PRODUCT/PROCESS CHANGE NOTICE (PCN)

PCN #: A1804-01 DATE: 18-Apr-2018 Product Affected: TSE2004GB2C0NCG TSE2004GB2C0NCG8 Date Effective: 18-Jul-2018	MEANS OF DISTINGUISHING CHANGED DEVICES: <input type="checkbox"/> Product Mark <input type="checkbox"/> Back Mark Assembly lot# prefix: <input type="checkbox"/> Date Code "TF" denote TFME, China <input checked="" type="checkbox"/> Other "HT" denote HTC, China
--	---

ATTACHMENT 1 - PCN # : A1804-01

PCN Type: Manufacturing Site - Alternate Assembly, Test & Backend Location

Table 1: Carrier Tape Comparisons

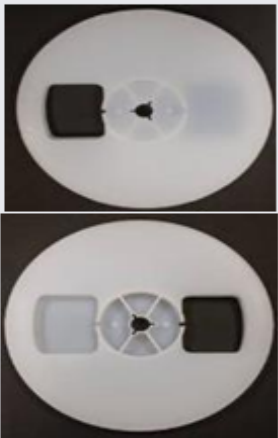
Carsem, Malaysia	TFME, China
Part Number	C-PAK BD0200x0300	ECA1941-PS-BLK-520
Ao	2.3+0.1mm	2.3+0.05mm
Bo	3.2+0.1mm	3.2+0.05mm
Ko	1.0+0.1mm	1.0+0.05mm
P	4.0+0.1mm	4.0+0.1mm
W	8.0+0.3mm	8.0+0.2/-0.1mm
Drawing	Refer Page 7	Refer Page 8
Snapshot

Table 2: Plastic Reel Comparisons

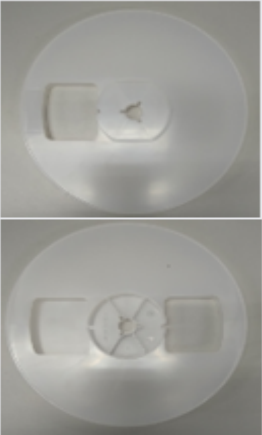
Carsem, Malaysia	TFME, China
Part Number	NEWTECH P9-065-000 White	E-PAK eRL0126-T08-A47-TRL
Reel Dia	7"	7"
Hub Dia	2"	2"
Drawing	Refer Page 9, 10	Refer Page 11
Snapshot

HTC Carrier Tape

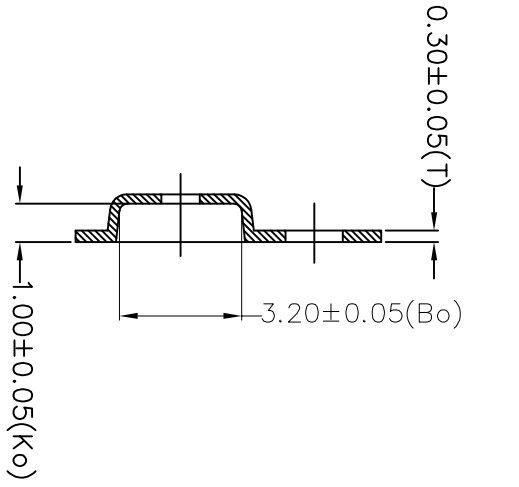
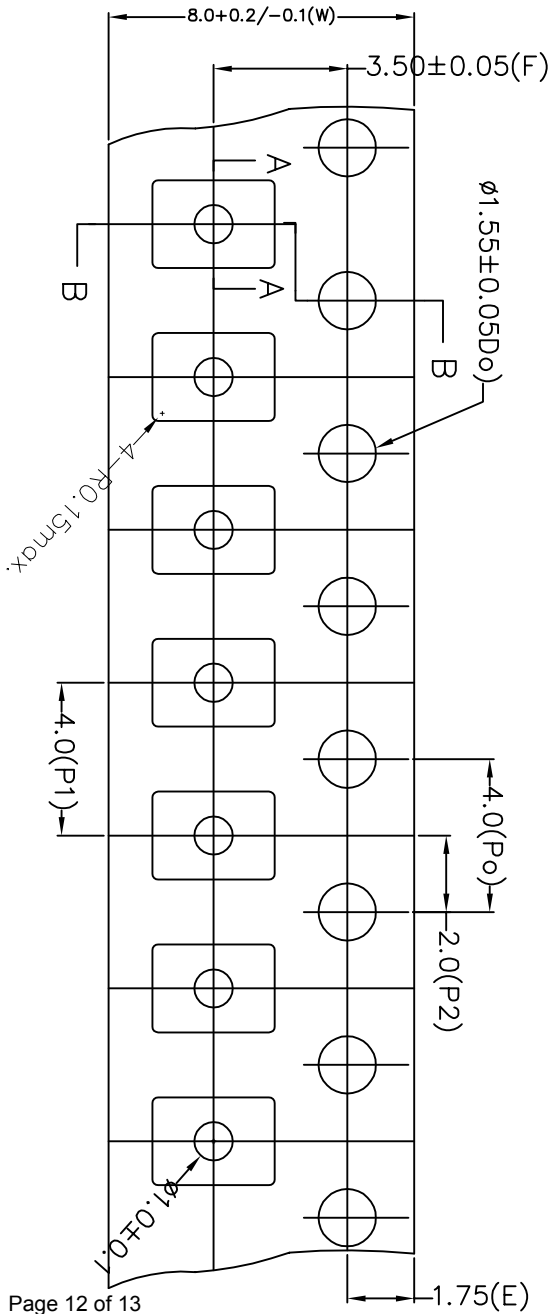
Carsem, Malaysia	HTC, China
Part Number	C-PAK BD0200x0300	ECA1941-PS-BLK-520
Ao	2.3+0.1mm	2.3+0.05mm
Bo	3.2+0.1mm	3.2+0.05mm
Ko	1.0+0.1mm	1.0+0.05mm
P	4.0+0.1mm	4.0+0.1mm
W	8.0+0.3mm	8.0+0.2/-0.1mm
Drawing	Refer Page 7	Refer Page 12
Snapshot

TITLE:		7" PLASTIC REEL FOR 8 MM	
STOCK NO.	DRAWING NO.	SCALE	
N/A	MSC-8402-A	N/A	
DO NOT SCALE DRAWING	SHEET 1 OF 1	REV	00
		SIZE	N/A

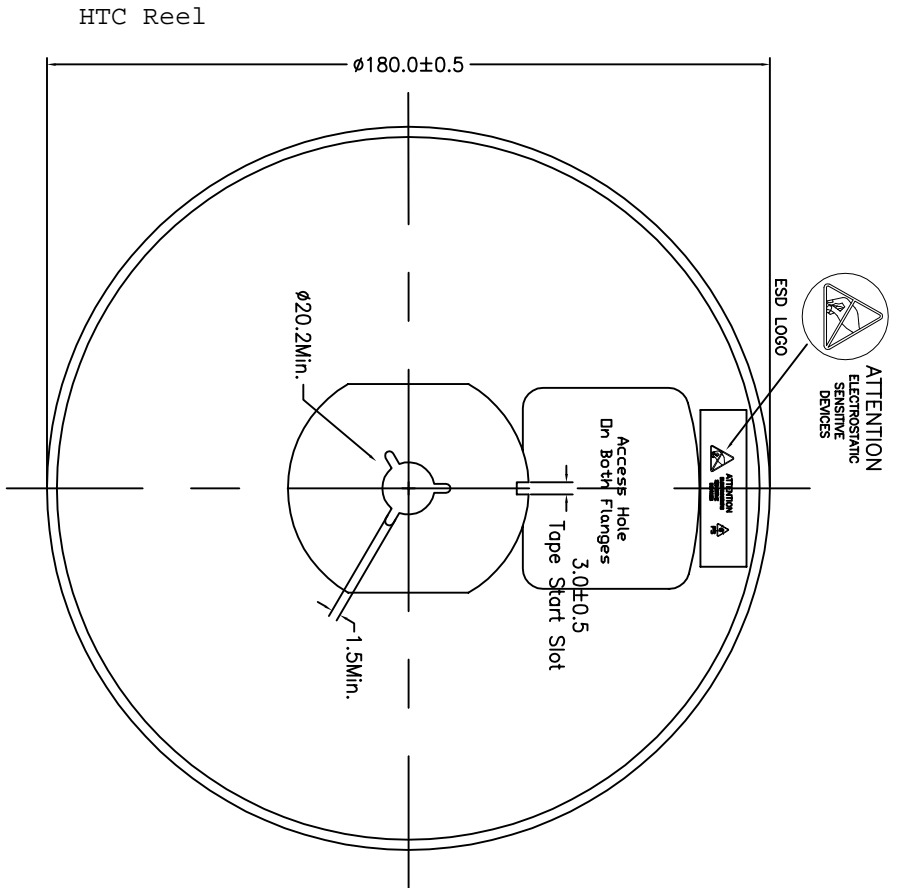
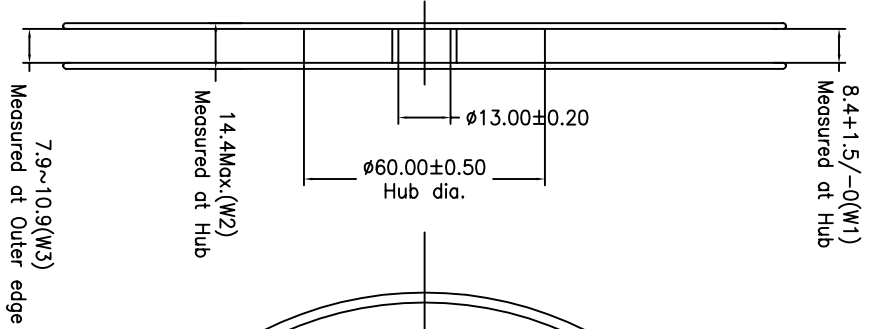
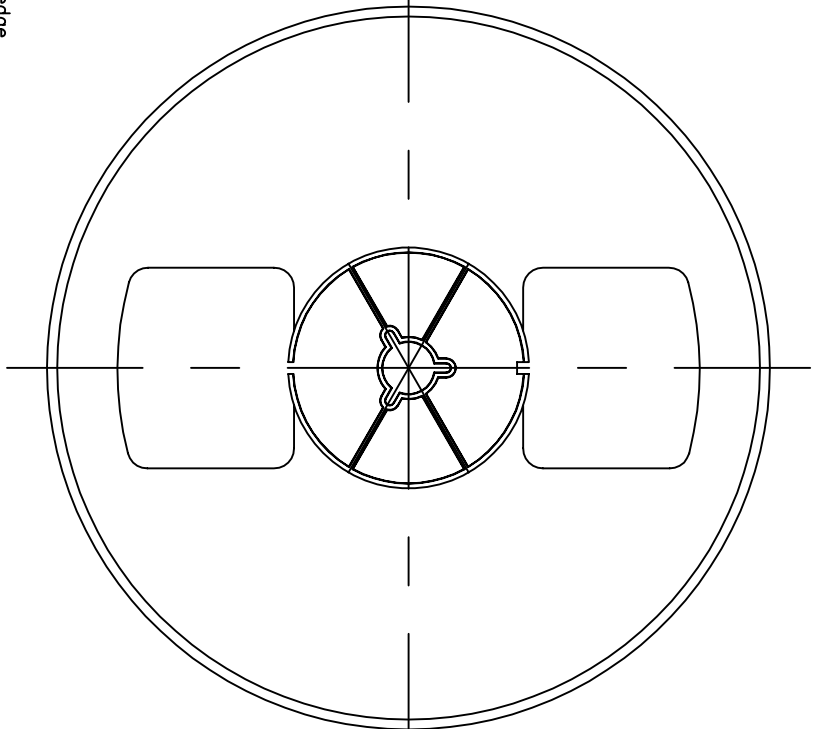
Carsem, Malaysia	HTC, China
Part Number	NEWTECH P9-065-000 White	E-PAK eRL0126-T08-A47-TRL
Reel Dia	7"	7"
Hub Dia	2"	2"
Drawing	Refer Page 9, 10	Refer Page 13
Snapshot
